**LEVEL 10
477 COLLINS STREET
MELBOURNE VIC 3000**

RFI AND REFERRAL RESPONSE LETTER PLANNING PERMIT PA2201886

Urbis continues to act on behalf of the permit applicant with regards to the above-mentioned planning application seeking to construct and operate a renewable energy facility at 1000 Little River-Ripley Road, Little River.

Figure 1 Vegetation Quality Assessment

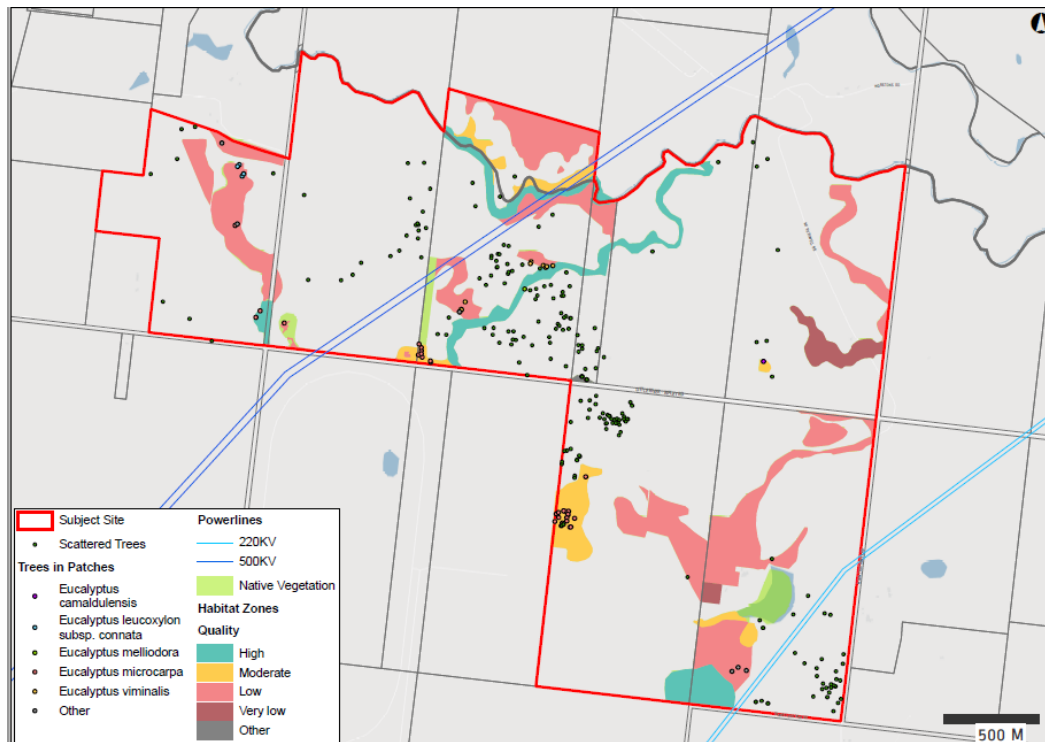
Following discussion with the Department on the 15 December 2022, the proposal has been amended to investigate opportunities to minimise the removal of scattered trees.

As indicated on Figure 1, the design has avoided the majority of plains grassland within the site in order to avoid significant impact to critically endangered FFG Act listed species (Golden Sun Moth), even though it is considered low quality vegetation. Note, whilst this patch of EVC heavier soil Plains Grassland is considered to be of low quality, it meets the key condition threshold for Natural Temperate Grassland of the Victorian Volcanic Plain (EPBC Act listed).

The revised design now seeks to avoid the installation of solar panels immediately south-east of the ecological corridor in order to preserve a greater number of scattered trees. These trees have been prioritised for retention, as they assist in improving connectivity and the area of remnant vegetation along Sandy Creek. In the design presented in the original Planning Permit application, 97 of the 187 scattered trees and 10 of the 38 patch trees were identified for removal. In the current design, scattered tree impacts have been reduced to 70 trees and patch reduced to 5 trees. This equates to 33% of all the trees mapped within the study area (reduced from 47% of all the trees). Please refer to Figure 3 Below.

There is currently no alternative location which would reduce the impact on native vegetation without resulting in significant amenity impact to neighbouring properties to the east. Noting the plains grassland proposed for removal is of poor quality and not considered important native vegetation (please refer to Figure 1&2 below).

Figure 3 Site plan presenting indicative geological units contained within the proposed site boundaries

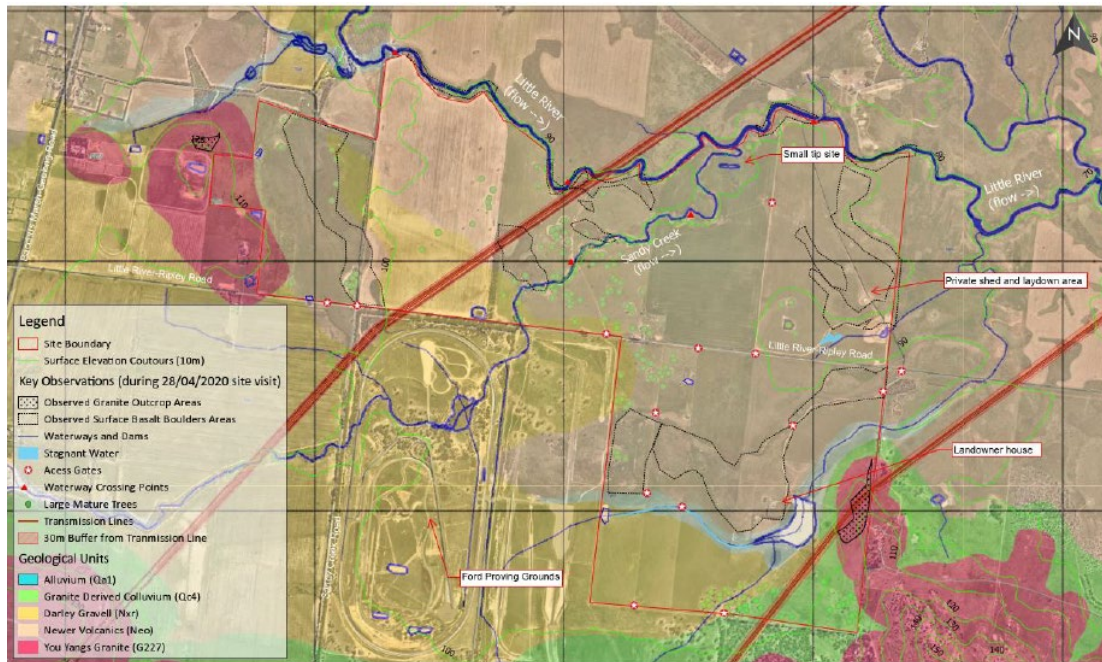
Consideration has been given to the installation of solar panels in areas of low-quality plains grasslands located in the north west of the subject which are not considered Golden sun moth habitat, in order to preserve a greater number of scattered trees onsite. However, following further geotechnical investigation into the western portion of the site, variable surface condition were identified with shallow rock encountered in numerous locations, specifically basalt boulders as shown in figure 2.

The presence of shallow rock significantly impedes on the ability to install piles/rodes that support solar panels. With a potentially irregular rock surface and floaters such as basalt and granite, many

profiles would normally be required to fully characterize rock depths. Additionally, if the areas have large uneven outcrops, these areas will need to be flattened and evened, which would result in significant time and cost implications. Overall, the presence of rock in the western portion of the site makes the installation of solar panels infeasible.
